Amendments to the Drawings

Remarks/Arguments

FIG. 2

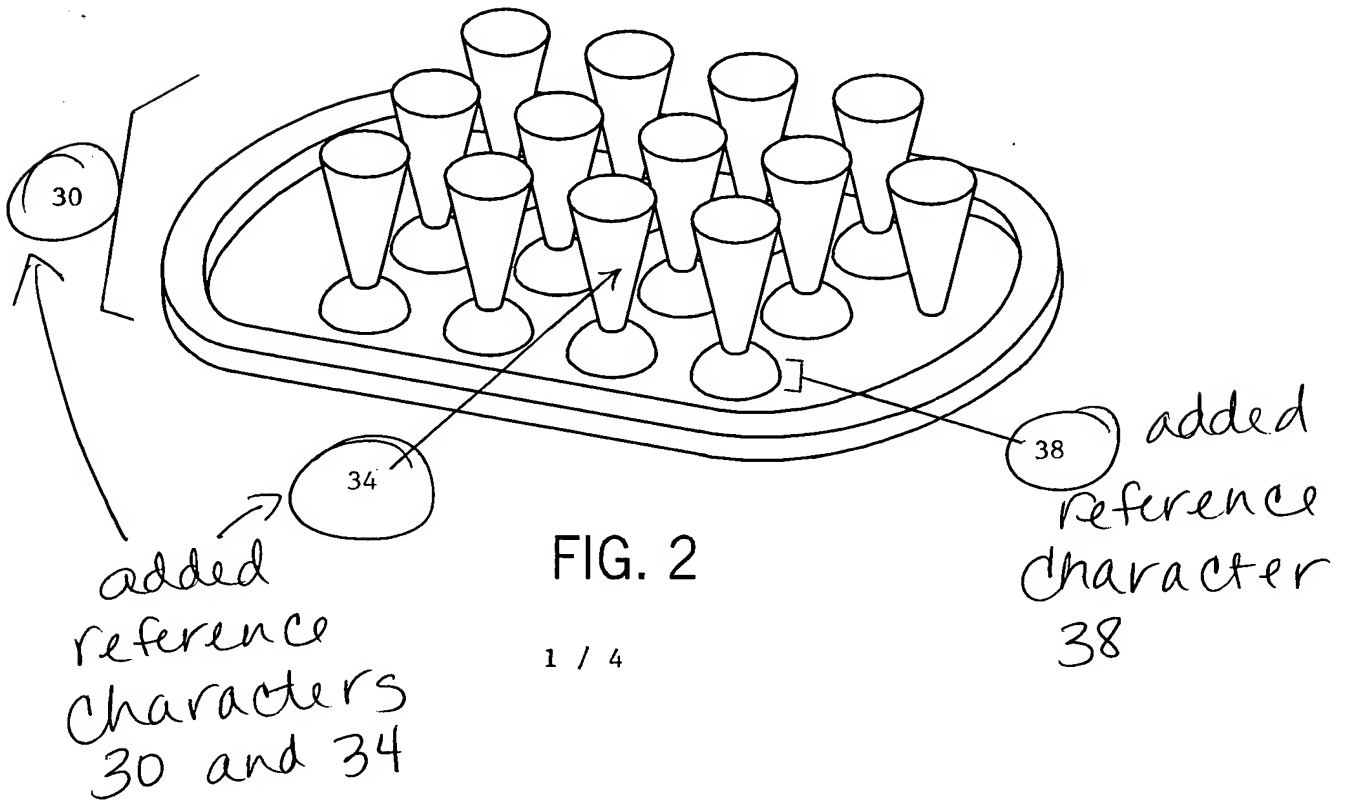
The Examiner also asserts that Figures 2 through 5 do not include the reference characters mentioned in the specification. In response, applicants have amended Figures 2 through 5 of the drawings to comply with 37 CFR §1.84. Specifically, applicants submit herewith replacement sheets and corresponding annotated sheets for Figures 2 through 5, showing that the reference characters have been included.

Please replace the existing Figures 2 through 5 with the attached replacement sheets and an annotated sheet showing changes to Figures 2 through 5. In Figure 2 previously omitted reference characters 30, 34 and 38 have been added. In Figure 3 previously omitted reference terms directed towards the sample loading array, channel, subarray and microarray have been added. In Figure 4 previously omitted reference characters 10, 15, 18, 19, 40, 42 and 44 have been added. In Figure 5 previously omitted reference character 50 have been added.
